### **Response letter**

### **Review of amtd-8-7737-2015**

#### **EARLINET Raman Lidar PollyXT: the neXT generation by R. Engelmann et al.**

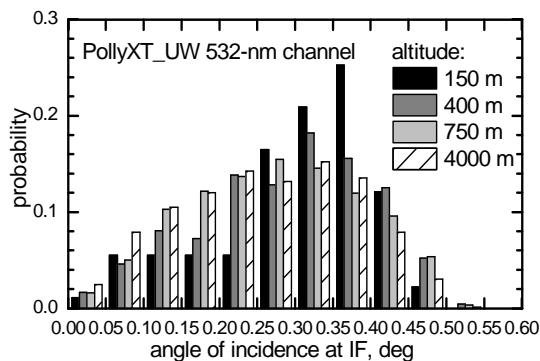
Where is the compromise?

We mean the compromise between designing a "fast" overlap function for low altitudes and a "slow" overlap function to measure signals in the tropopause for calibration. The fixed signal dynamic range

always demands such a compromise. Measurements from 50m to 20km height already demand a signal dynamic range of 5 orders of magnitude only based on geometrical considerations (not including variable backscattering and extinction).
